PARKLANDS VILLAGE 2 PHASE 2

DATE:
06/07/2023 SITE PLAN 01

SHEET TITLE:
LANDSCAPE
PLAN

PARKLANDS VILLAGE 2 SUBDIVISION FILING NO. 2

SHEET 6 OF 13

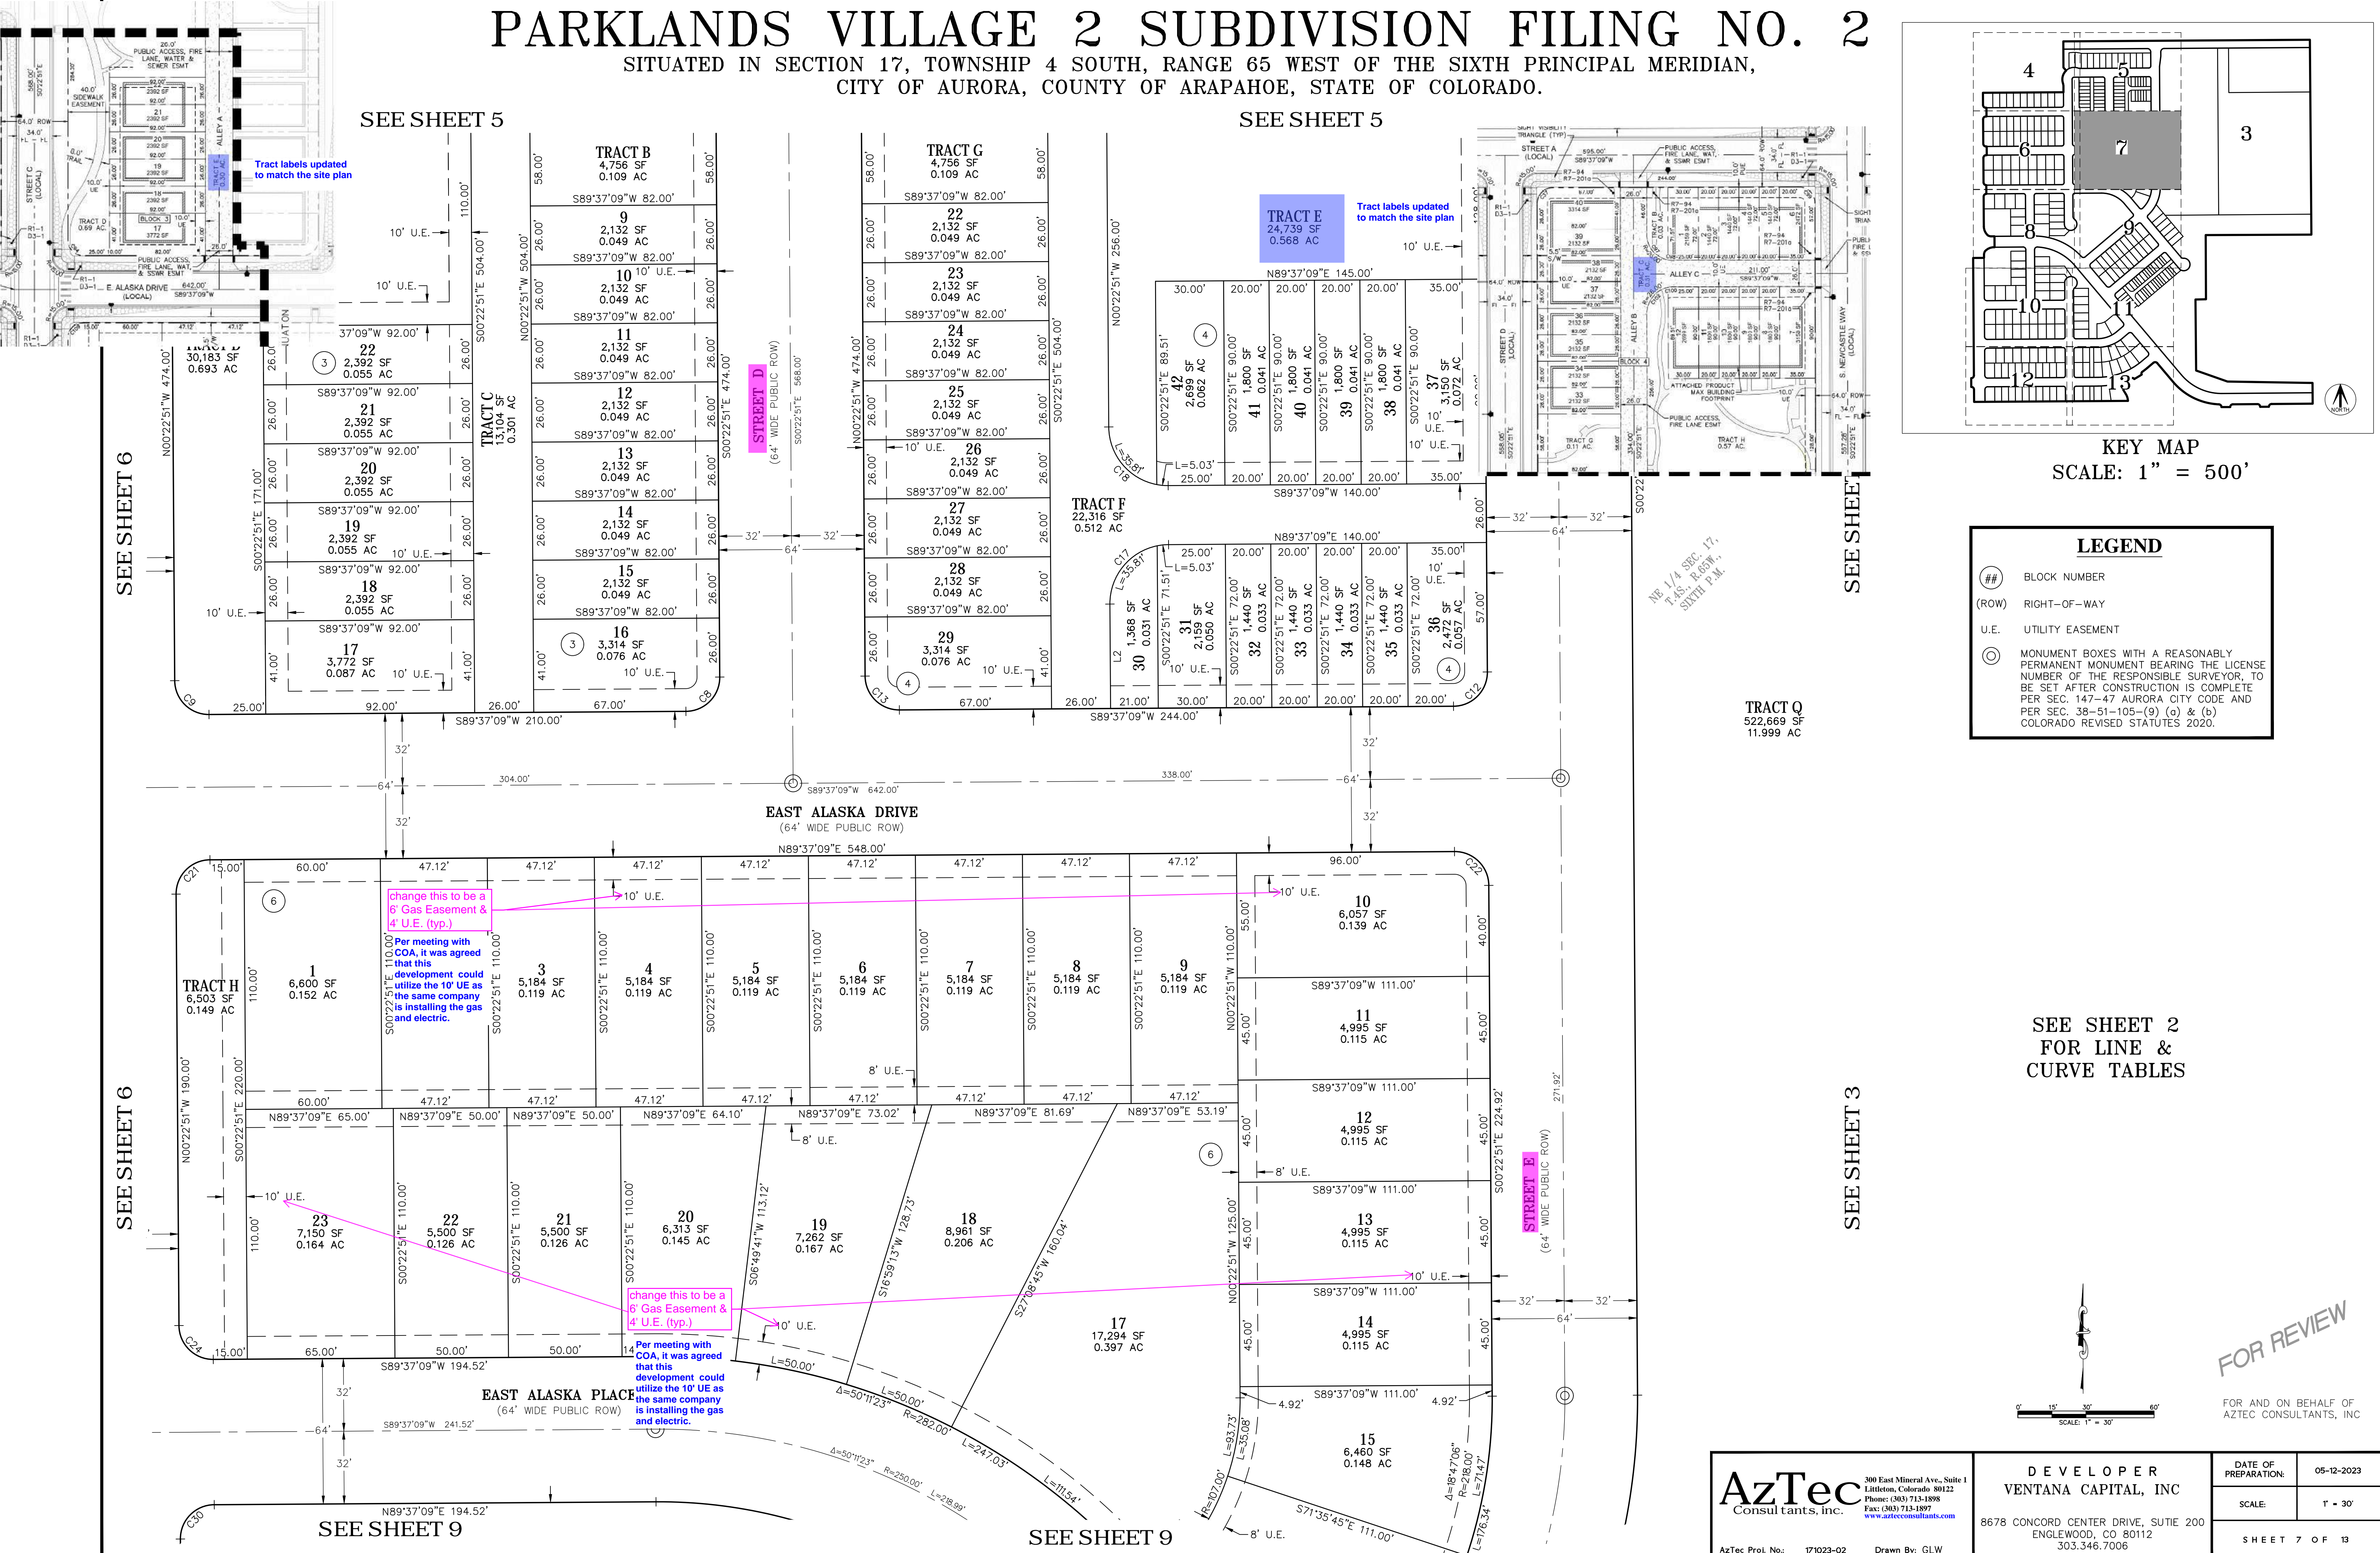
add the centerline bearing and distance between the pins - add inter pin
Added info

add the centerline bearing and distance between the pins - add inter pin
Added info

add the centerline bearing and distance between the pins - add inter pin
Added info

change this to be a 6' Gas Easement & 4' U.E. (typ.)

change this to be a 6' Gas Easement & 4' U.E. (typ.)

change this to be a 6' Gas Easement & 4' U.E. (typ.)

change this to be a 6' Gas Easement & 4' U.E. (typ.)

Per meeting with COA, it was agreed that this development could utilize the 10' UE as the same company is installing the gas and electric.

SHEET 12 OF 13

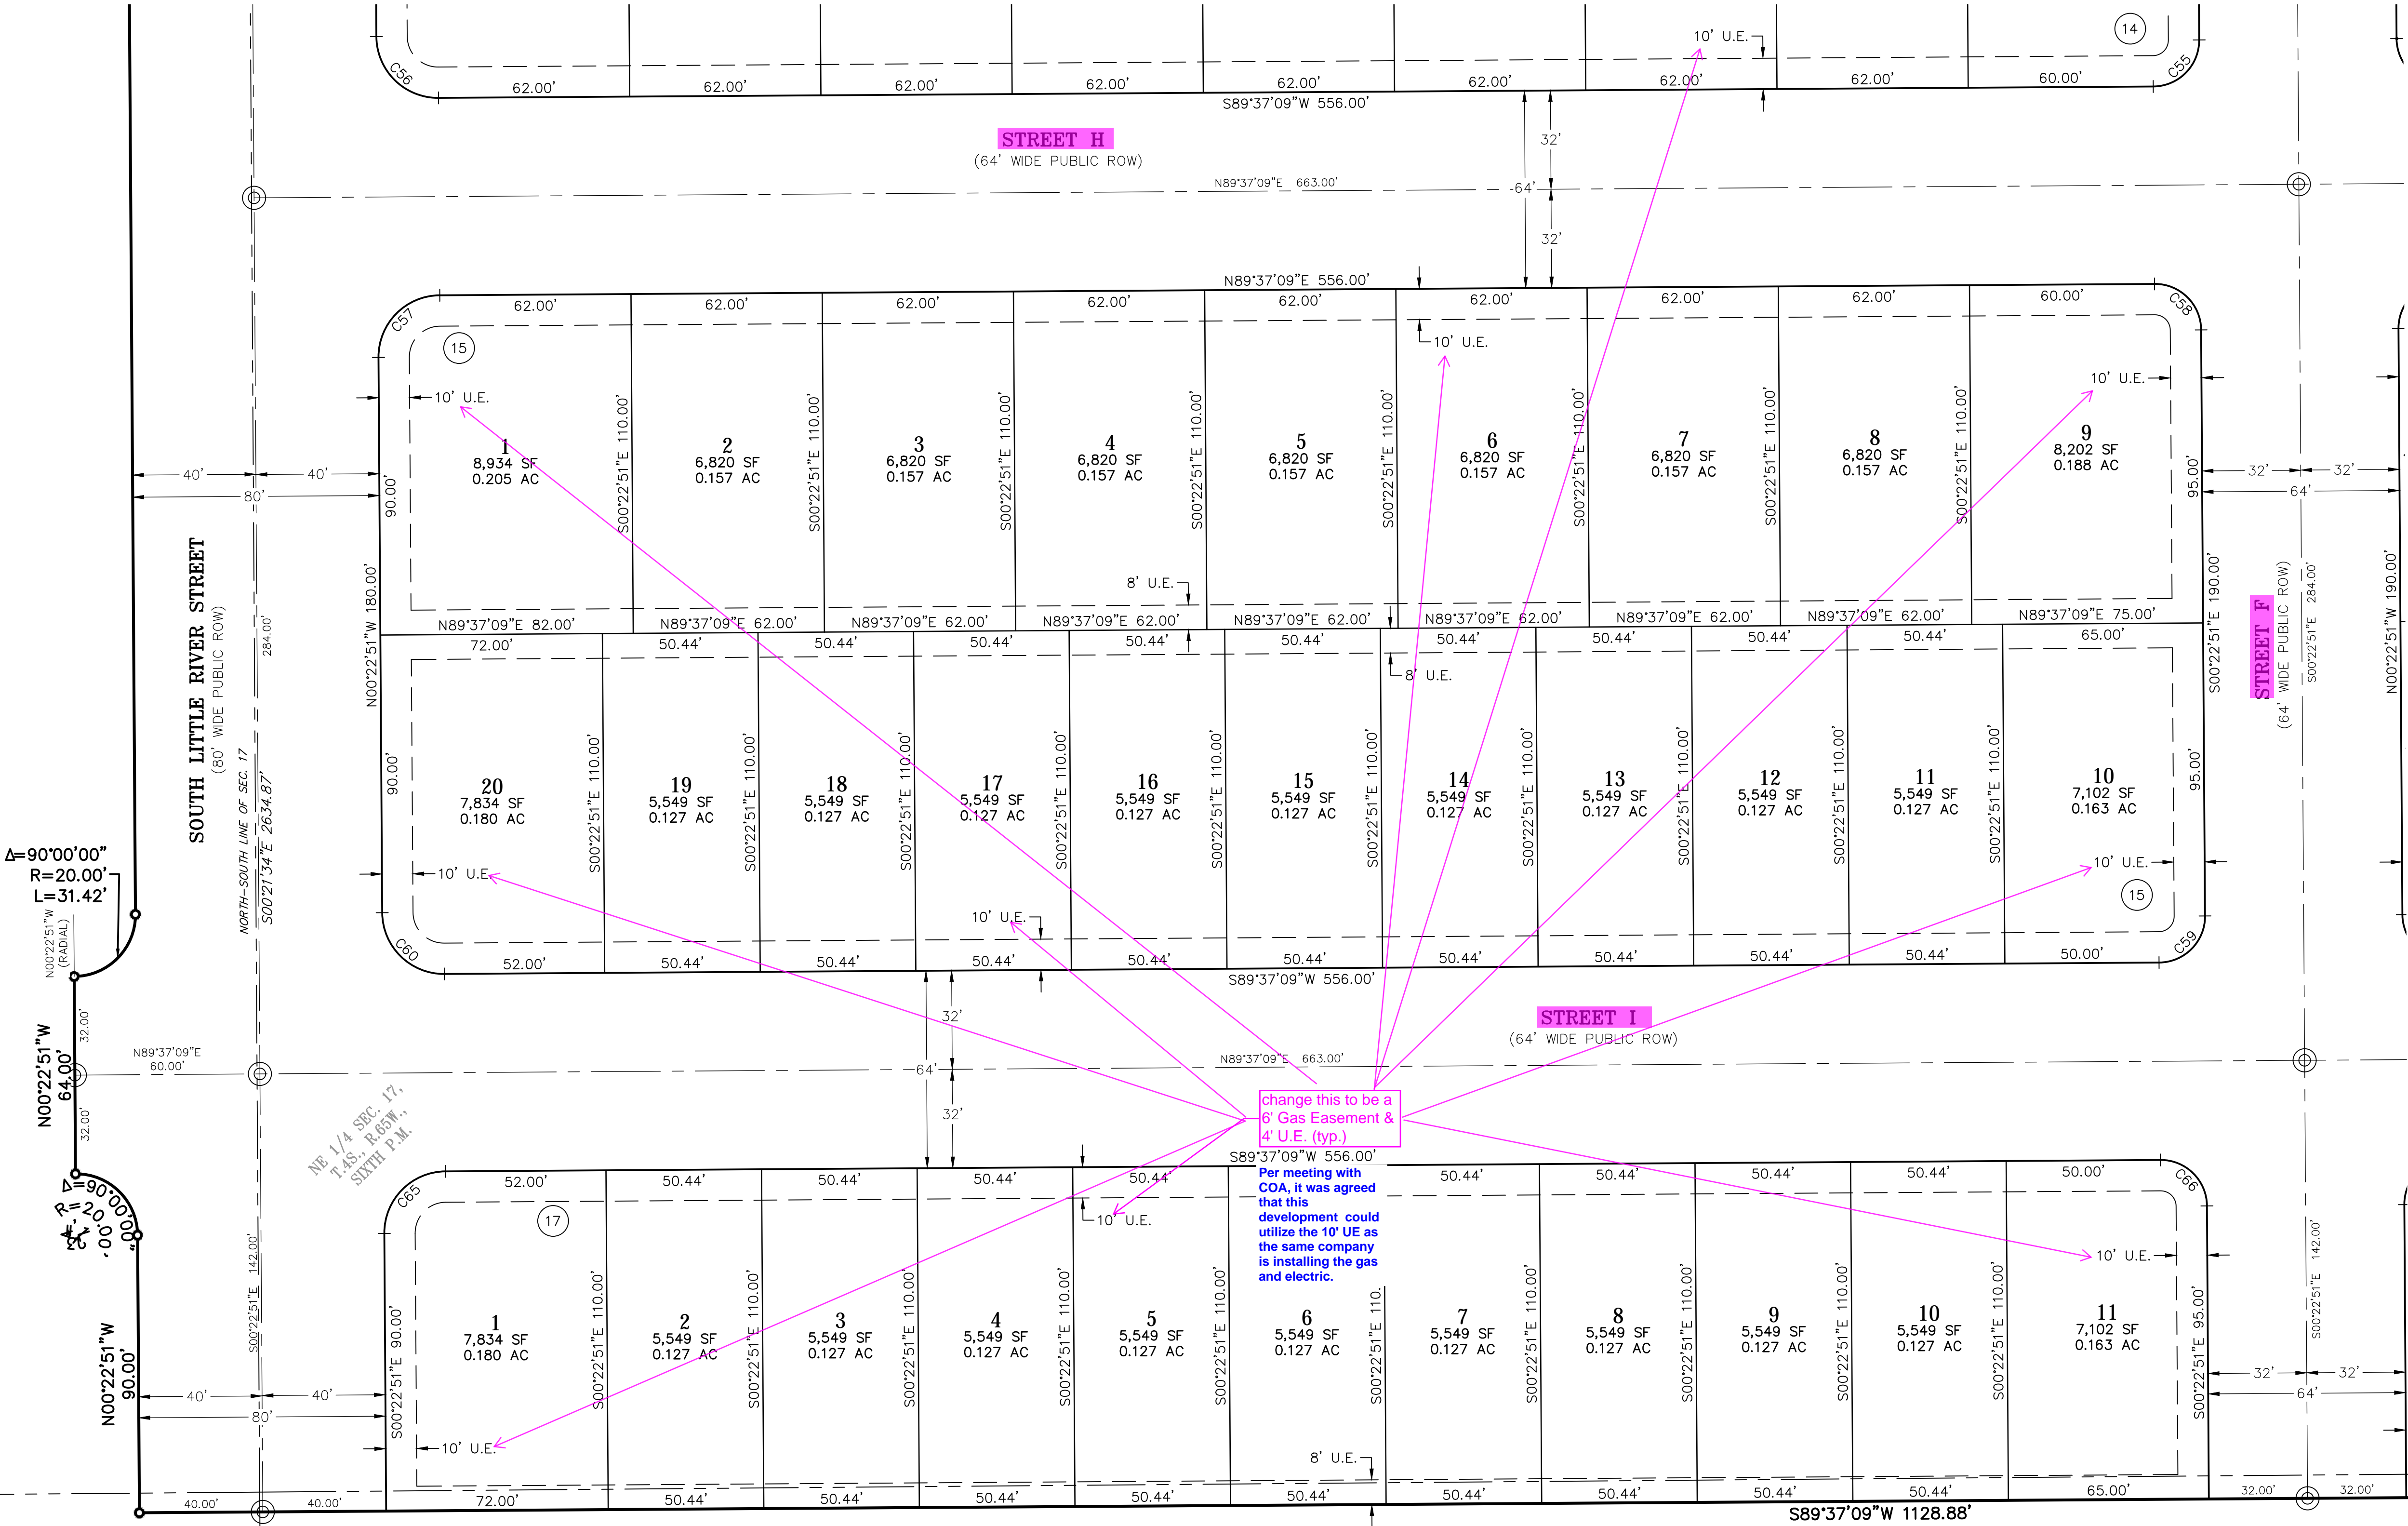
Show and label the Centerlines and intersection pins - add the Bearings, Distances and Curve Data of the Centerline

added
sheet 14
to capture
this street

FIGURE 4
PARKLANDS VILLAGE
AURORA, COLORADO
2023 ADJUSTED

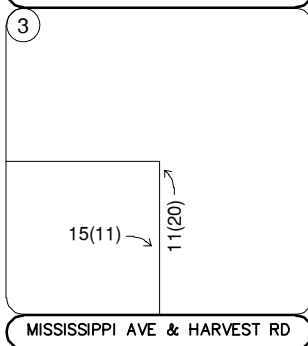
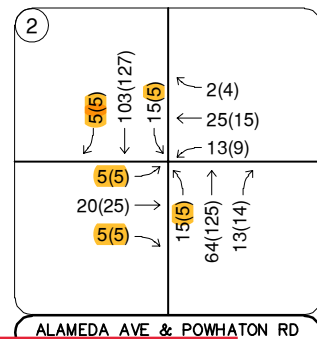
Highlighted traffic numbers less than the 2022 values in the previously approved Phased study, please reconcile

In studying this inconsistency between the two studies, it was found that the volumes in the previously approved study during the adjusted existing scenario were incorrectly overinflated (i.e. these movements in that study were larger than the 2025 background volumes for those same movements in that same study). Only the adjusted existing scenario was slightly incorrect in that regard for the previously approved study---all other scenarios were correct.

As such, these volumes in this current study have been kept the same as they are shown on this figure. We apologize for this mistake in the previous study. However, because the primary analysis periods of concern are the buildout horizon years, which were correct, the results and recommendations of that study (and this study) are unaffected.
